TOWN OF ASTATULA
Planning & Zoning Commission Meeting
Thursday, May 22, 2025 – 6:00 PM
Astatula Town Hall
25009 County Road 561 | Astatula, FL 34705

**RE: Mack Concrete Expansion
Halff # 059233.001
Request for Additional Information #2 - Major Site Plan**

CONSTRUCTION PLANS
FOR
MACK CONCRETE
156,000 SF EXPANSION

Project Name Mack Concrete expansion
Project Phase Site Plan only not full civil plans
Discipline: Engineering
Reviewed by: Dana S Johnson, P.E.
Review Date: 04/22/2025
Contact: dajohnson@cgasolutions.com , 954-766-2744
Review: ☐ 1st Rev. ☐ 2nd Rev. ☒ 3rd Rev.

SECTION A-A
NOT TO SCALE

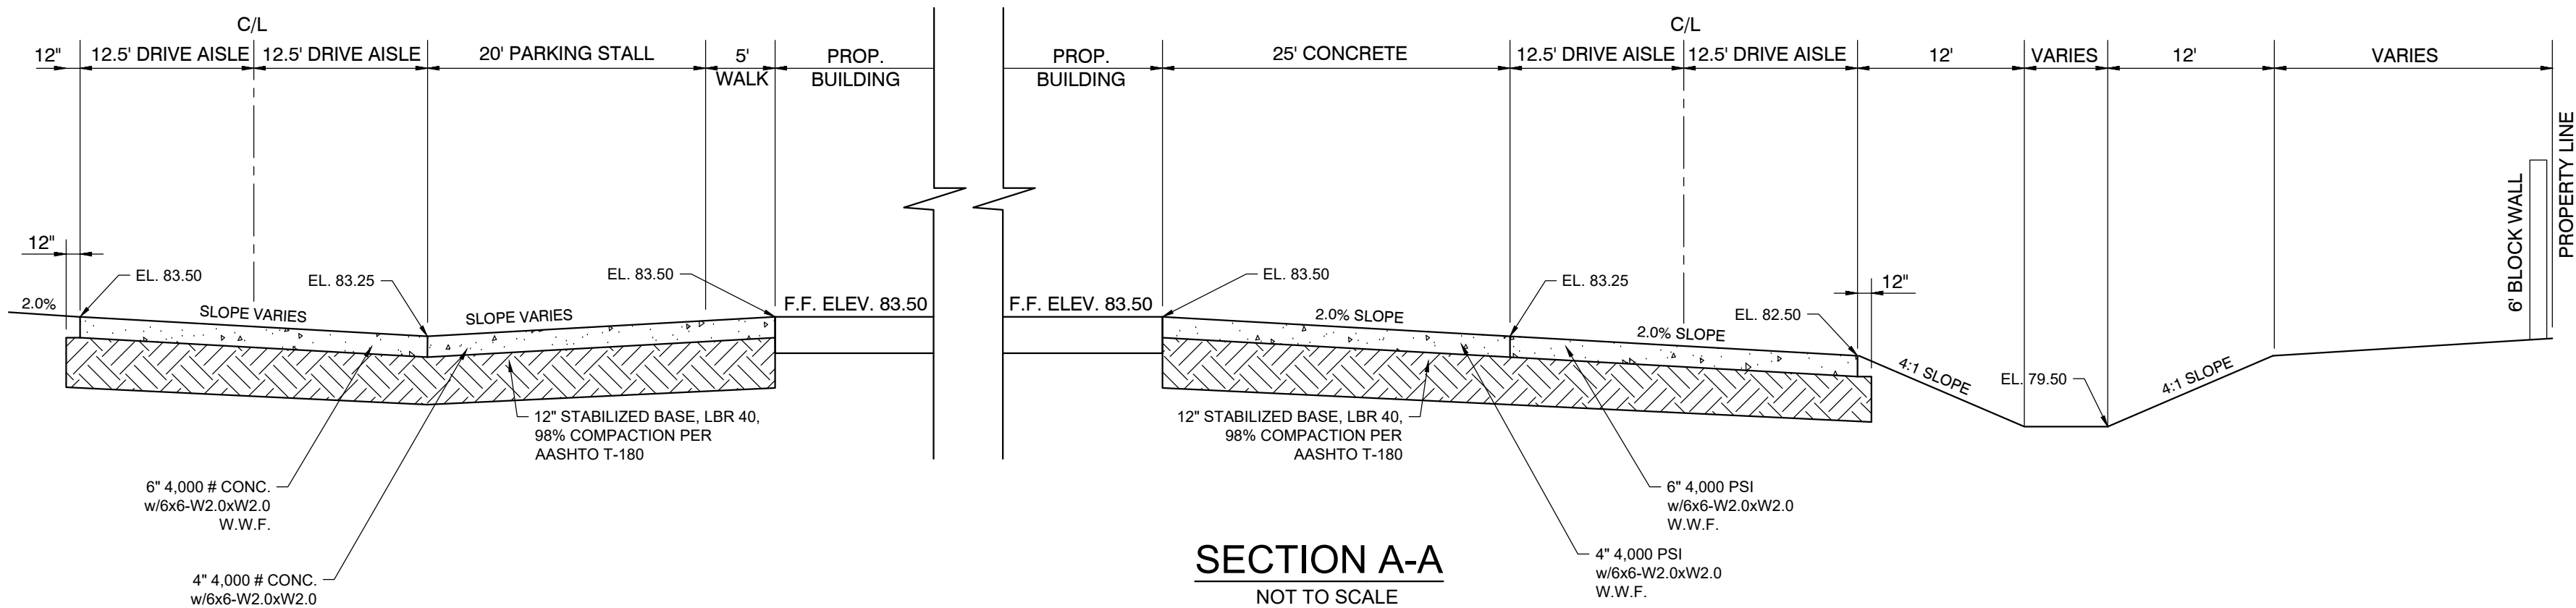
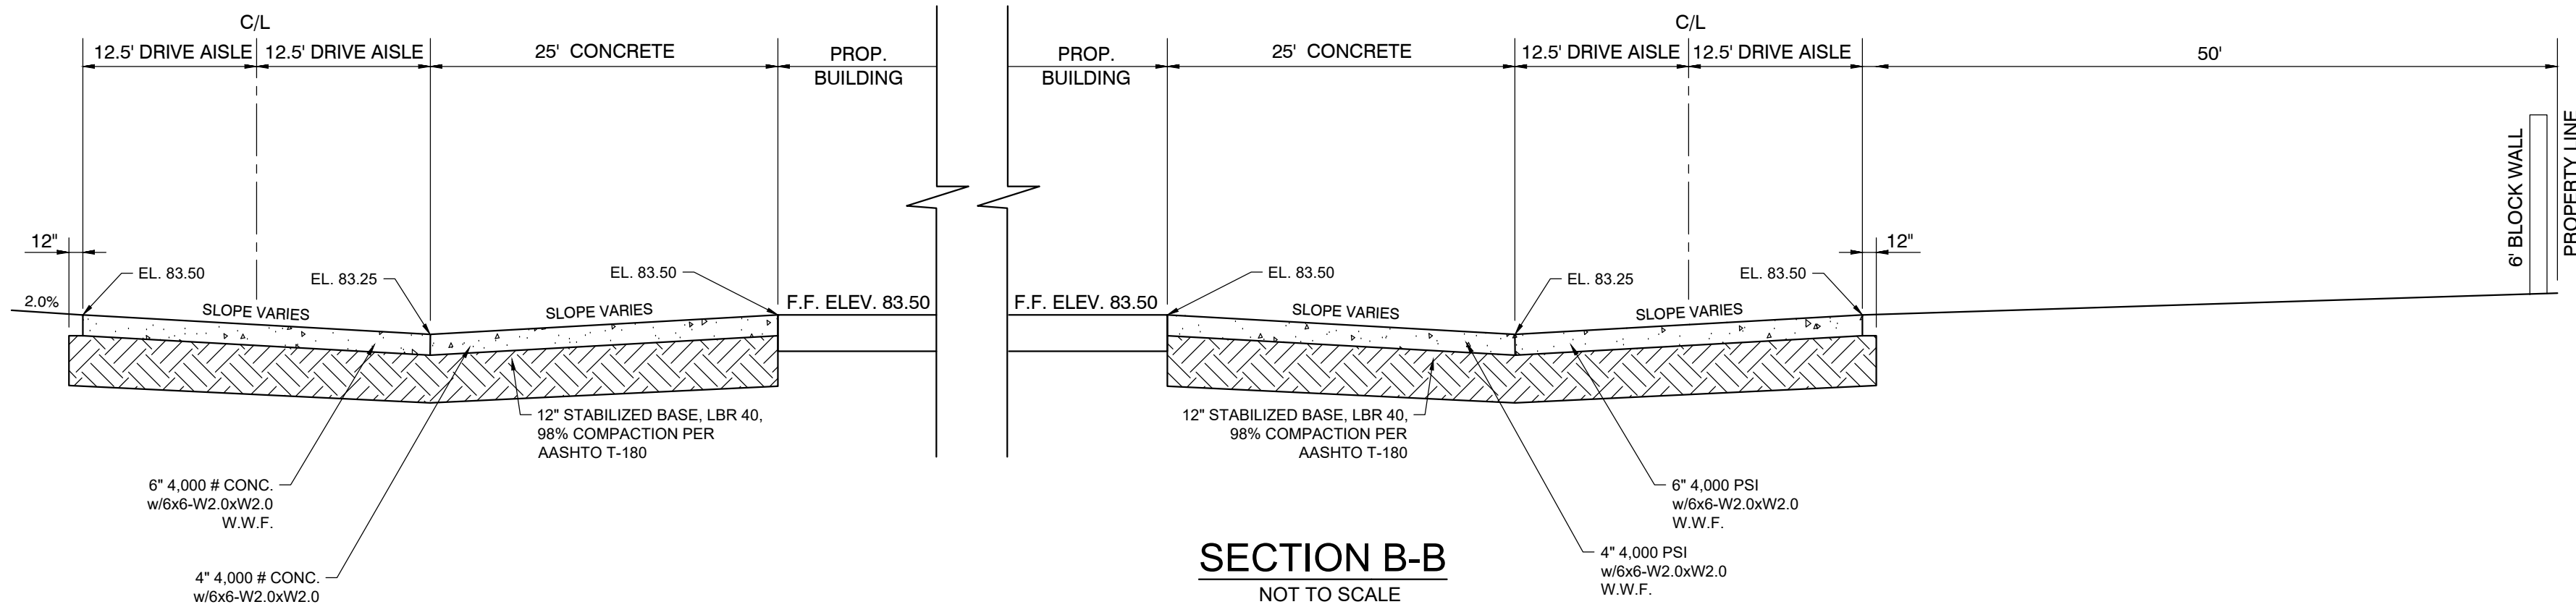
5. Provide cross sections on all sides of the new building showing how paving and drainage will be handled.

****PENDING.** Cross sections were not provided with the revised site plan. Cross Sections will be required with the full civil plan submittal and must be approved prior to issuance of a building permit.

Response: See Sheet C-3
